Apex Textile Printing Mills (Extension)

2. Observation

Observation-1: Design concrete strength needs to confirm by further testing (10 Story Corporate Office Building)

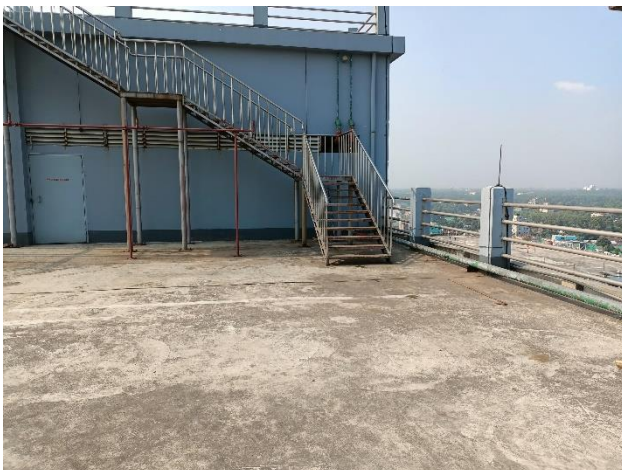
Description: In the provided design report concrete compression strength is considered 5000 psi for column & foundation. The factory has provided only a two-cylinder test report for the column in this regard, which does not meet the frequency of testing of BNBC. Also, column was found marginally overstressed considering 6 Kpa live load. The building engineer is required to revise the concrete strength in the design report by performing a core test.

Observation 2: Lack of drawings for roof steel stairs. (10 Story Corporate Office Building)

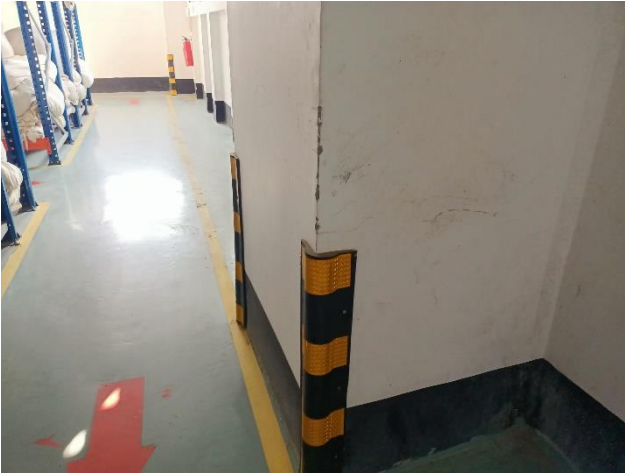
Description: During the inspection, 3 nos of steel stairs were found on the roof adjacent to the stair room. However, no structural details were found for these stairs. The building engineer is required to prepare the as-built drawings with complete structural details.
